DEVELOPMENT REVIEW BOARD REPORT

CASE NUMBER/ **5-DR-2003#4**

Dannys Family Carwash

REQUEST Request approval for site plan and elevations for a carwash/service station

L101

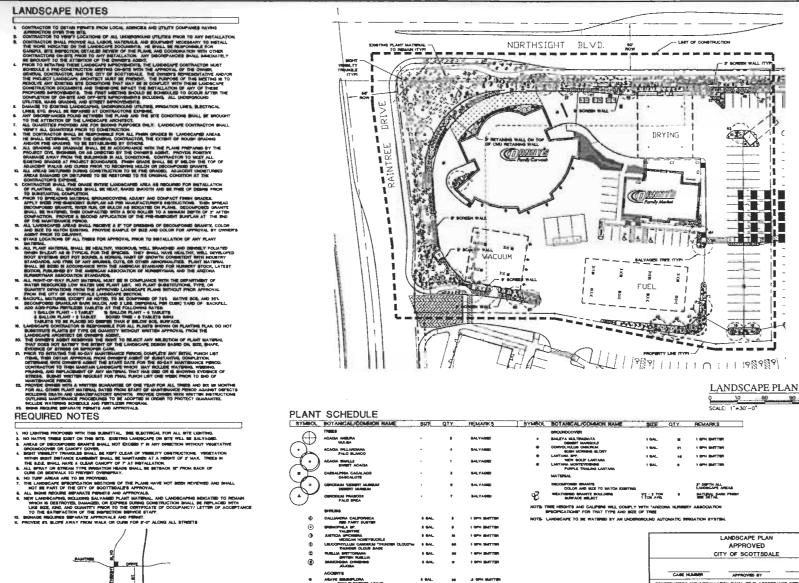
- c. Landscaping, including quantity, size, and location of materials shall be installed to be consistent with the conceptual landscape plan sheet L101 submitted by Deutsch Associates with a staff receipt date stamp of 2/2/2005.

A-2

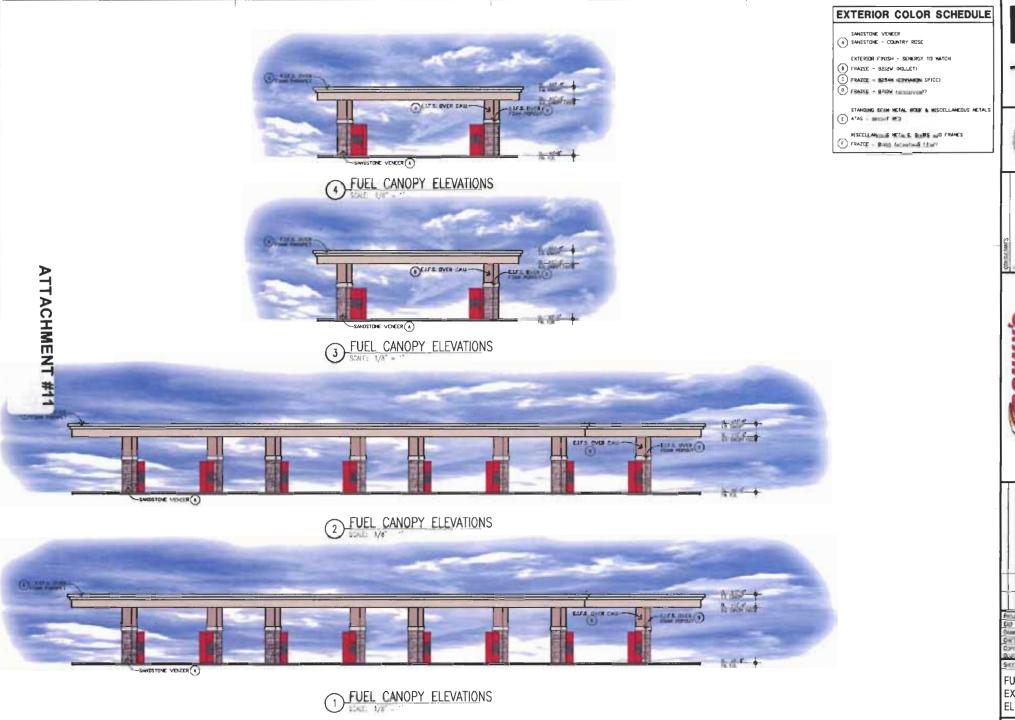
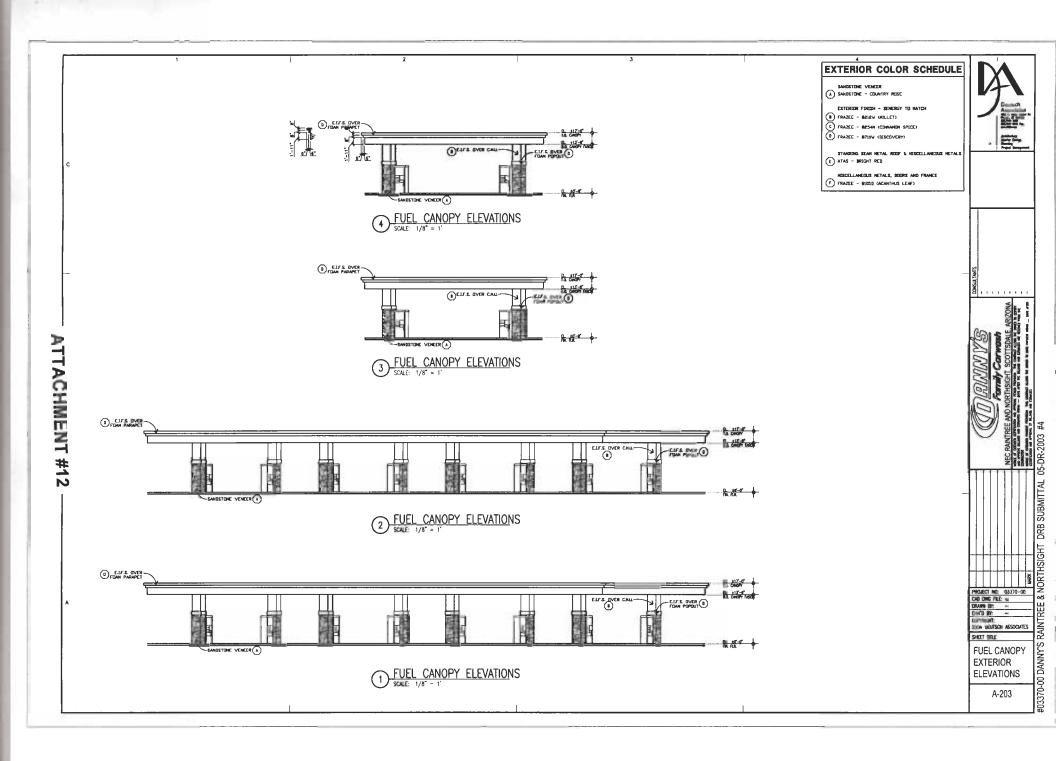
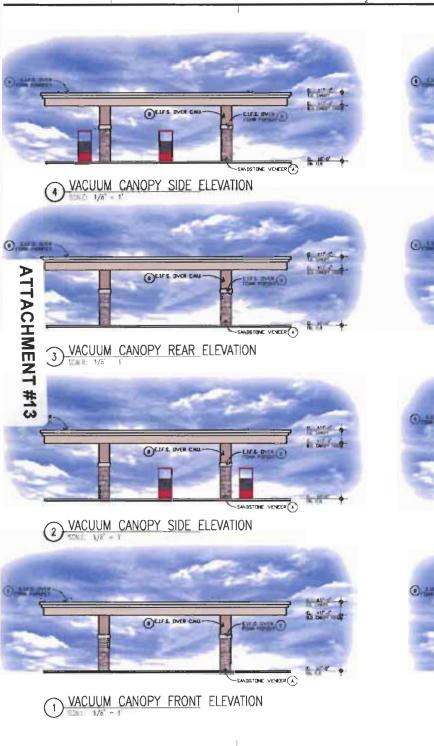
- Architectural elements, including dimensions, materials, form, color, and texture, shall be constructed to be consistent with the building elevation sheets A-201, A202, and A204 submitted by Deutsch Associates with a staff receipt date stamp of 1/18/2005, 1/18/2005, and 10/22/2004, respectively.
